Proposed Contingency Authorization # 47

Collin County JJAEP Facility
McKinney, TX
Owner: Collin County

Description: **PCO #47- for RFI #84-Gyp fur downs at C123 nd C124**

RFI #84
PLO # 97

13 FURR DOWN DETAIL

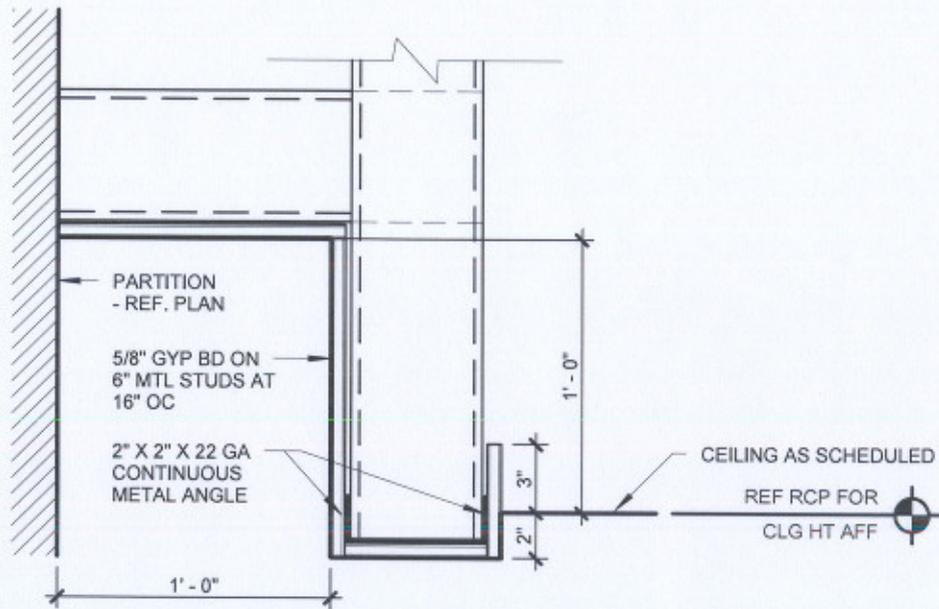
Rooms C123, and C126 both have storefront systems that separate them from the main corridor. The rough opening for the windows is called out to be 10ft tall, however the ceilings heights in these rooms is 9'-0" AFF. Does the intended finish include a soffit at the intersection of the ceiling and storefront that will be visible from the corridor? Do these ceiling heights need to be raised?

If they need to raise, we have some piping issues that will need to be addressed (i.e., chilled water and fire sprinkler)

See attached ceiling plan and detail 13/A3.00. Swap out a 2x4 light fixture in room C123 with a 2x2 from hallway of IDF C114.
